Questions from the FCC

ROGERS LABS, INC. Harmon Industries, Inc. 4405 W. 259th Terrace MODEL: AATC-SSR

Louisburg, KS 66053 Test #: 000614 FCCID#: AJTAATCSSR-24 Phone/Fax: (913) 837-3214 Test to: FCC Parts 2 and 15c Page 1 of 3

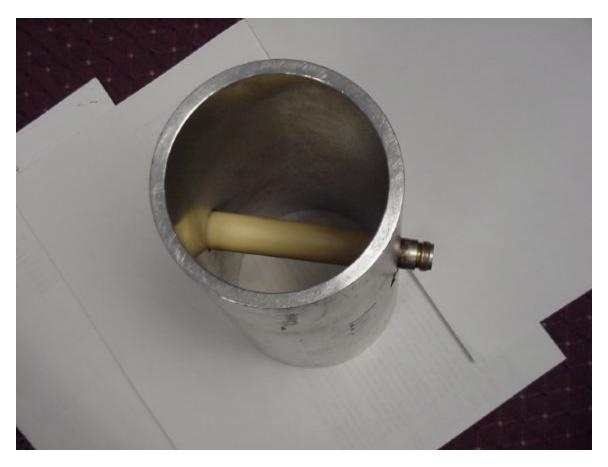
2. MPE info indicated there is only one antenna available for this system, which described the typical antenna gain is 6 dBi but not exceeding 10 dBi. It also indicates that a picture of the antenna is included in the report. Please provide specific information on the antenna type and gain. It is not clear according to the photos submitted whether the cylindrical structure next to the transmitter is the antenna. It seems to have radomes on both ends of the cylinder, please clarify.

The statement should read LESS THAN 6 dB of gain. Again, this was used for MPE demonstration purposes only. The radio frequency exposure is not what is going to injure someone in the path of this TRAIN. The antenna is a metal cylinder with plastic covers on both ends to keep foreign objects from damaging the spike antenna inside. Refer to the pictures below showing the antenna removed from the cylinder and a picture down the inside of the tube.
